**Fermilab**

TO: E. G. Pewitt
FROM: Gregg Kobliska *Gregg*
SUBJECT: Trip Report Teledyne Roll Forming
J & L Steel 50MM Dipole Cold Mass Skins

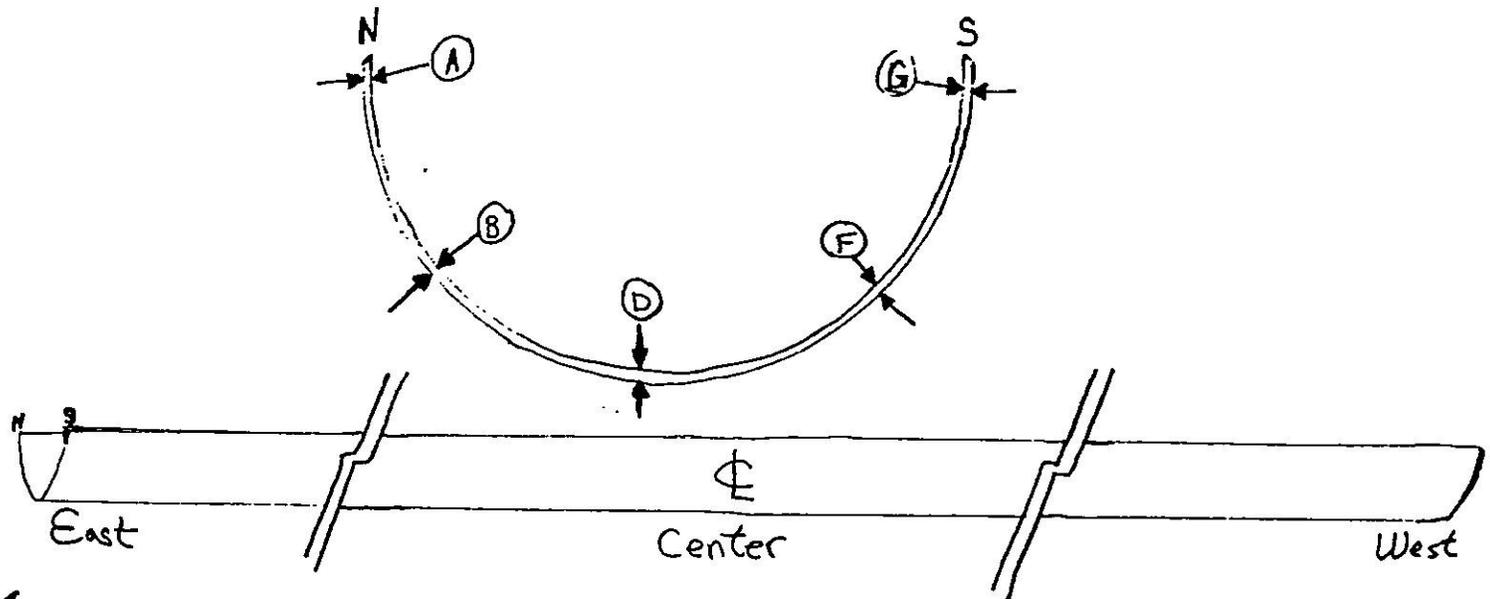
I was able to verify one skin as being acceptable, with the machine producing a good product as I left. There are some concerns relating to the drawing that should be addressed. They are as follows:

1. The 20 microinch finish is not attainable. The raw steel was measured in the mid to upper 20's by Teledyne prior to roll forming. We should do our own measurements at Fermi, but a more realistic number on the drawing is probably somewhere between 25-35 microinches. The drawing should also state the finish is required on both sides of the part.

2. The tolerance on the flat of the weld prep detail is not achievable. Currently this is .020" plus/minus .005". Teledyne has asked for plus/minus .020" on this. The variation on this is because it is machined in the free state. Since Teledyne can do better than they're asking, I suggest plus/minus .010 or .015.

3. Due to the way stresses are introduced into the part during roll forming, the trailing end of the part has more end flaring than we experienced in the 40MM program. We're seeing this condition extending approx. 18-24" into the part. Again, I think the drawing should reflect this.
